Service Bulletin

Rudder cable clearance on Cessna 206H, T206H equipped with Kelly Aerospace Thermal Systems Air Conditioning per STC SA03302CH.

Figure 1
Improper Routing of Rudder Cable
Rudder cable is caught between mounting bracket and power stud on circuit board.

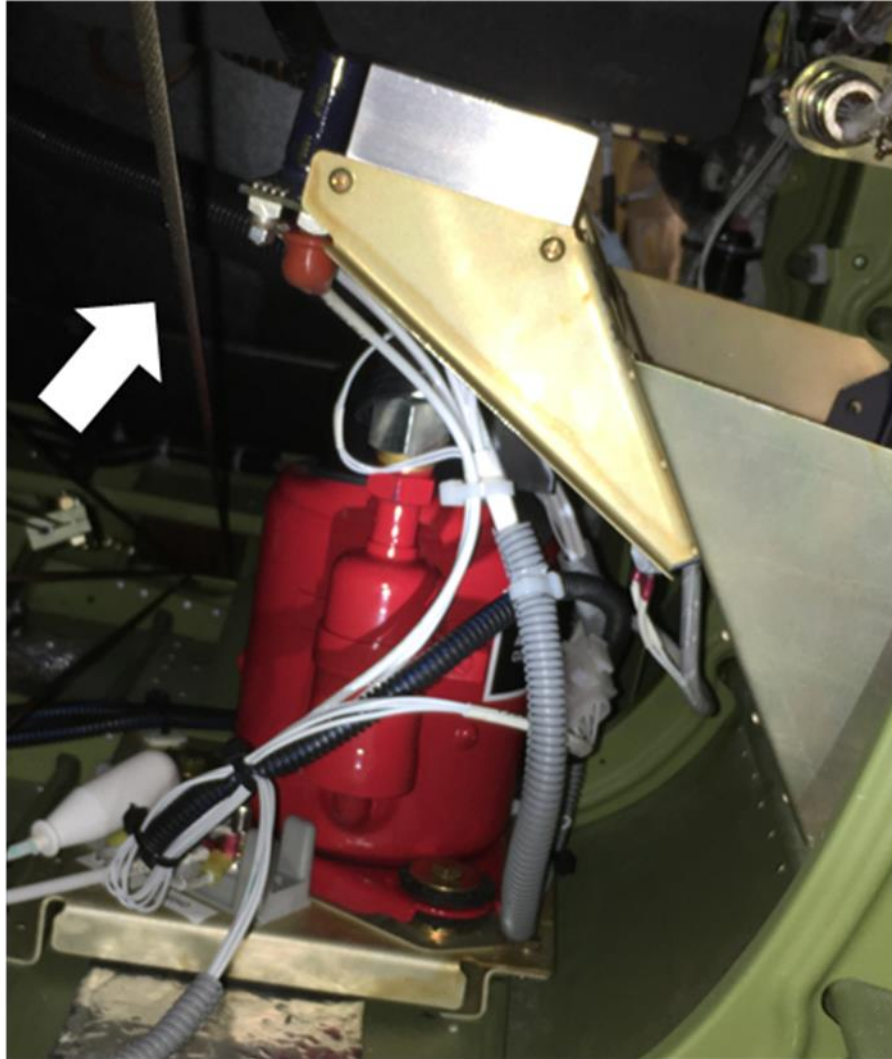
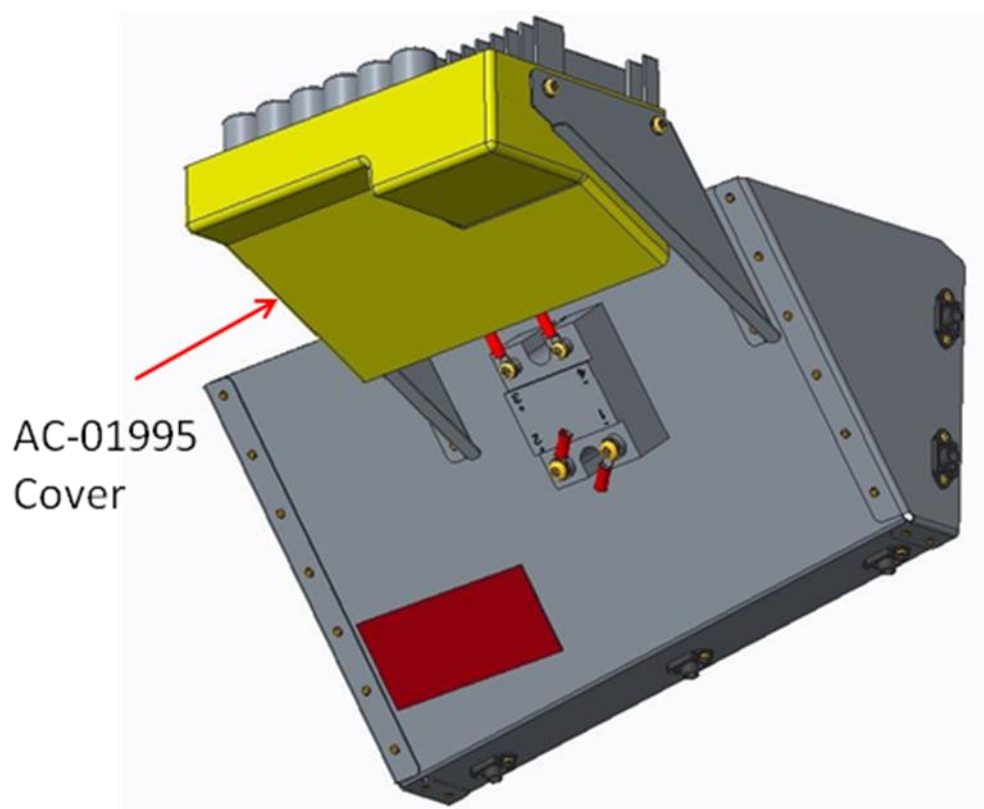
This service bulletin is being issued to notify owner/operators of Textron Aviation models 206H & T206H aircraft modified with the installation of the Kelly Aerospace Thermal Systems Air Conditioning of the possibility of rudder cable interference with the air conditioning control board. If the air conditioning inlet assembly is removed and then re-installed incorrectly the rudder cable can become caught between the AC control board and its mounting bracket which could lead to an eventual electrical short and damage to the rudder cable.

1. Remove access panel number 310AB (P/N: 1212439-1) from bottom of tailcone.
2. Inspect rudder cable routing in tailcone to verify that rudder cable is routed properly, see figure 1 for example of improper routing, see figure 2 for example of proper routing.
3. If the cable is found to be routed incorrectly, the cable routing must be corrected and the cable inspected for damage by a licensed airframe mechanic before further flight.
4. A cover for the control board has been designed to prevent the cable from being caught between the board and bracket and is available upon request from Kelly Aerospace Thermal Systems.
5. This service bulletin is recurring until AC-01995 cover has been installed, inspect per steps 1 & 2 of this procedure each time the air conditioning inlet is removed and reinstalled.
